May 19, 2005  
LIC-05-0065

**SUBJECT: Fort Calhoun Station Unit No. 1, Supplemental Response to Request for Additional Information on the Revised Relaxation Request for First Revised Order (EA-03-009) Establishing Interim Inspection Requirements for Reactor Pressure Vessel Heads at Pressurized Water Reactors**

**Supplemental Response to Request for Additional Information on the Revised Relaxation Request for First Revised Order (EA-03-009) Establishing Interim Inspection Requirements for Reactor Pressure Vessel Heads at Pressurized Water Reactors**

Figure 5-7  
Through-Wall Circumferential Flaws Near the Top of the Attachment Weld for CEDM and ICI Nozzles - Crack Growth Predictions (MRP Factor of 2.0 Included)

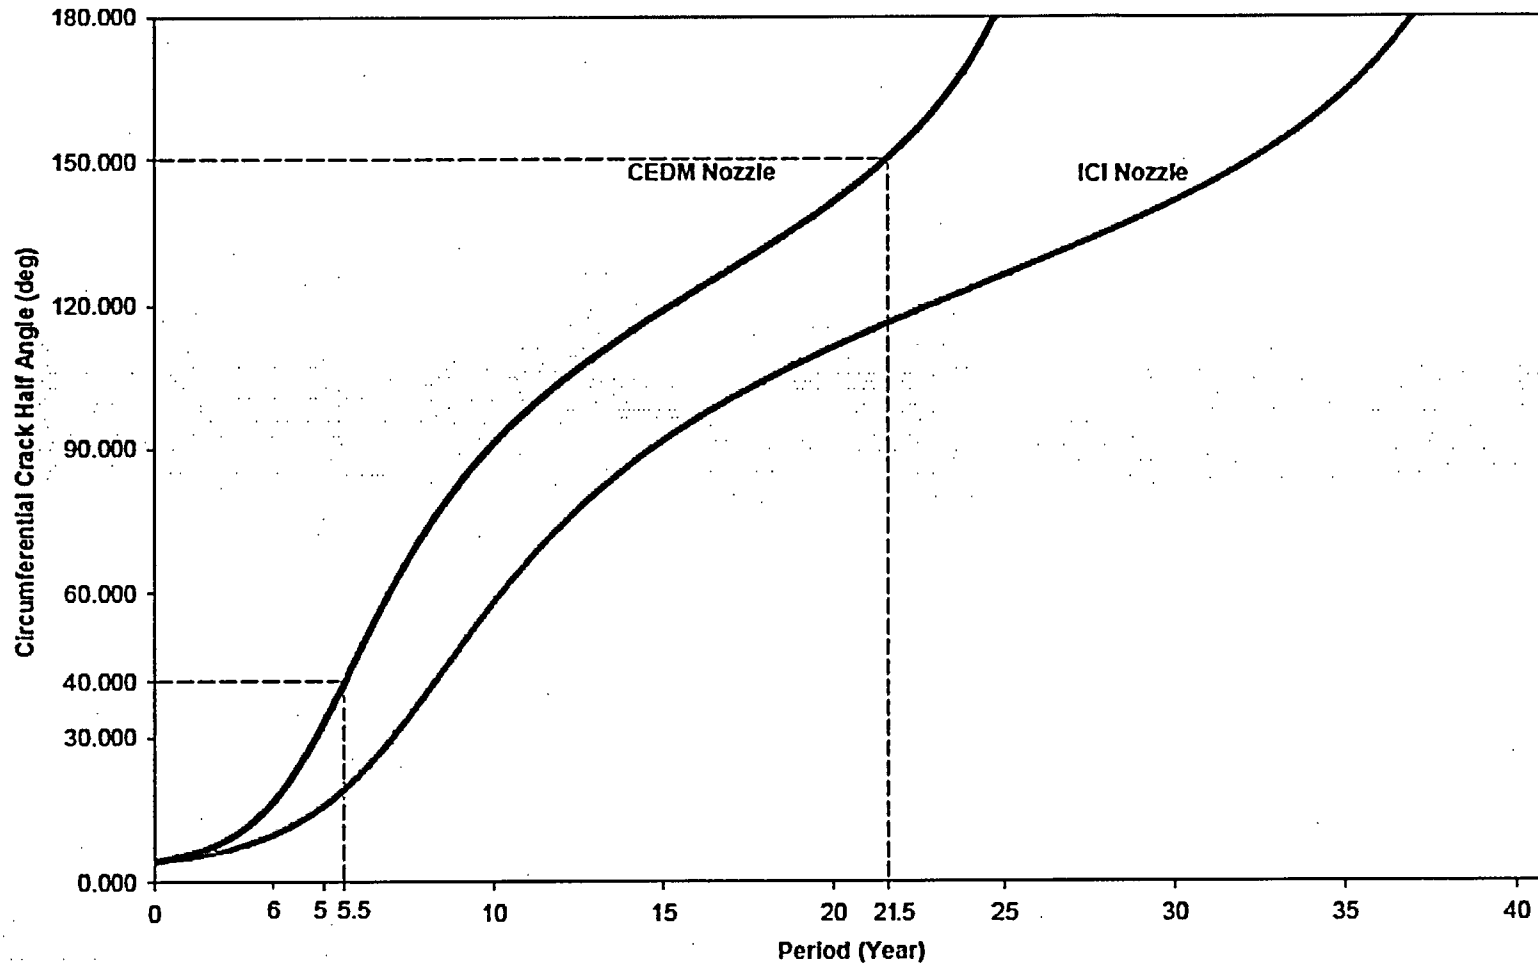
With regards to the Control Element Drive Mechanism (CEDM) Nozzle No. 25 relaxation request, assume a through-wall circumferential flaw in an 80 degree circumference (worst case scenario) is present in the uninspected area. Please provide discussion to confirm that it will take more than one operating cycle for a through-wall flaw of 80 degrees in circumference to propagate to 300 degrees, assuming 300 degree is the critical size. Also, please confirm that that Reference 8 [CEOG Report #CEN-614, "Safety Evaluation of the Potential for and Consequences of Reactor Vessel Head Penetration Alloy 600 OD Initiated Nozzle Cracking," December 1993] of Attachment 2 of Reference 2 is still applicable for Nozzle No. 25.

EPRi Report MRP-104 (Reference 1) discusses the time for a flaw to grow through-wall, and then the time for a circumferential flaw to reach critical flaw length. Figure 1 (excerpted from Reference 1) shows the time in Combustion Engineering Plants for circumferential flaws to grow to various sizes in CEDM and In-Core Instrumentation (ICI) nozzles. OPPD has added lines to this figure to show the areas of interest as discussed below.

Applying the conditions seen in CEDM nozzle 25 at Fort Calhoun Station Unit No. 1 (FCS), the time to grow from 40.000 degrees (equivalent to 80 degrees in nozzle 25) to a conservative critical flaw length of 150.000 degrees (equivalent to 300 degrees in nozzle 25) is approximately 16 years. This is well in excess of one operating cycle. The 16 years is conservative on both ends. The hypothetical flaw is not through-wall at FCS, because the bare metal visual examination found no boric acid deposits. Also, 300 degrees is conservative, because it is less than the 330 - 350 degrees required for CE Plants to reach critical flaw length.

CEOG Report # CEN-614, "Safety Evaluation of the Potential for and Consequences of Reactor Vessel Head Penetration Alloy 600 OD Initiated Nozzle Cracking," December 1993 remains applicable for CEDM penetration nozzle 25 at FCS. Reference 1 is a more recent report that contains similar conclusions.
